Contract Name  
 Tenney Park Pavilion

Change Order No. CO 1  
 Contract No. 6308  
 Project No. 53W0771  
 Change Order Project No.

Change Order Description  
 Overexcavate poor soil conditions under structural concrete footing areas and install clear stone foundation base material.

DESCRIPTION: Mass Undercutting - Proposed Alternate - Version 3

1 FOUNDATION PLAN  
 SCALE: 1/8" = 1'-0"

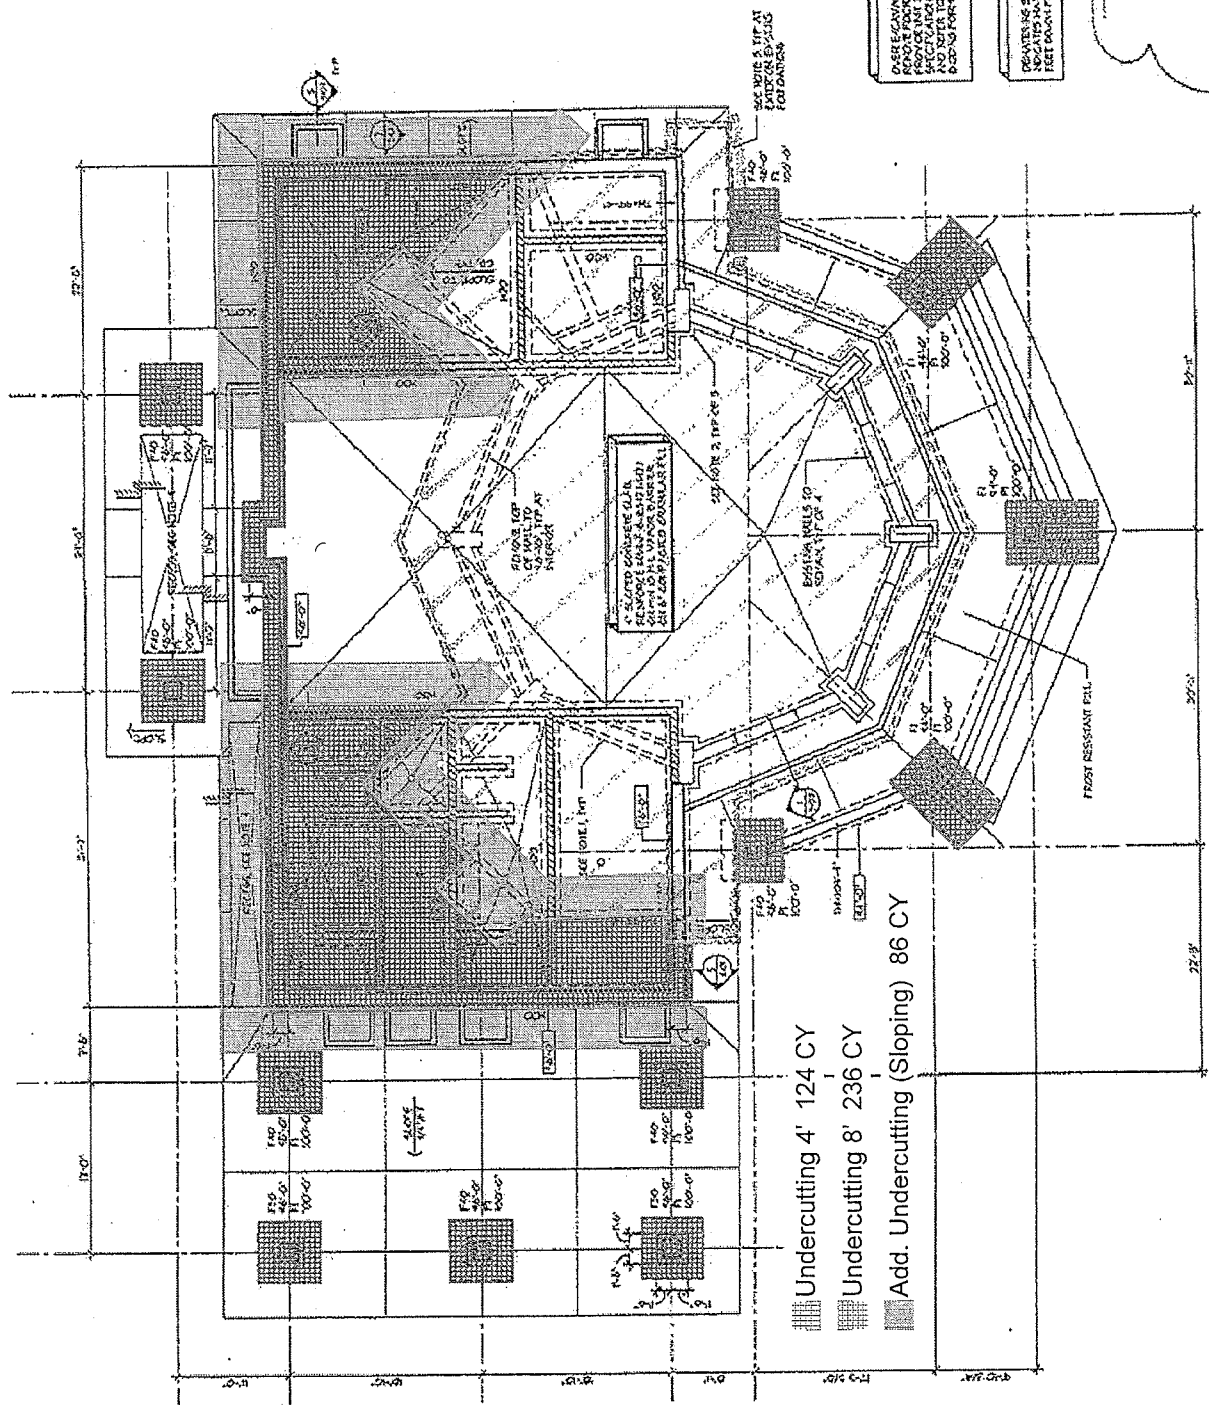
DESCRIPTION	QTY	UM	HRS	UNIT LABOR	UNIT MAT	LABOR	MATERIAL & EQUIP	SUB QUOTES	TOTALS
<p>Undercut existing subgrade per CGC field report #1 dated 4/12/2011 and A&amp;O proposed undercutting drawing (\$100) dated 4.29.2011 . Includes 446 CY of additional undercutting including sloping per attachments.</p> <p>Any additional undercutting beyond this scope of work will be billed at the following unit prices plus mark-up for overhead and profit.</p> <p>Excavation Cut - \$16/CY            Fabric - \$3/SY            3" Clear Stone - \$14/Ton            Sand Backfill - \$12./Ton</p> <p>Includes Type 1 dewatering per construction documents (C2.0) Note 9. If Type 2 or additional dewatering is required it will result in additional charges.</p> <p>General Conditions adjustment for adding (7) days to project duration. As a result of the unforeseen soil conditions, we stand to lose (15) days from the current project schedule if work cannot commence until 5/9/2011. To account for the additional work in this change order, (7) days need to be added to the project schedule.</p>							\$4,280	\$20,802	\$20,802

We recommend that the sand layer with peat seams be removed below footings and replaced with compacted gravel fill. The recommended sequence of operations would be as follows:

- 1) Undercut to about 7.5 to 8 ft below grade to remove the peat seams. Widen footing excavations 2 ft beyond the footing edge on each side. Work in short sections, with required material on hand before proceeding.
- 2) Immediately place about 6 in. of clear stone in the bottom and begin pumping from filtered sumps to control groundwater.
- 3) Place geotextile (WisDOT Type SAS) on top of the initial 6 in. of stone. Place and compact stone in lifts with a vibratory plate compactor or hoepak. Wrap the fabric above the stone once you reach footing grade. The stone should be enveloped by the fabric to prevent migration of fines into the open voids.
- 4) The dewatering pumps can be shut down as long as the water table stays below the top of the stone layer.

We anticipate that these procedures should provide a subgrade suitable for the design bearing pressure of 1000 lb/sq ft.
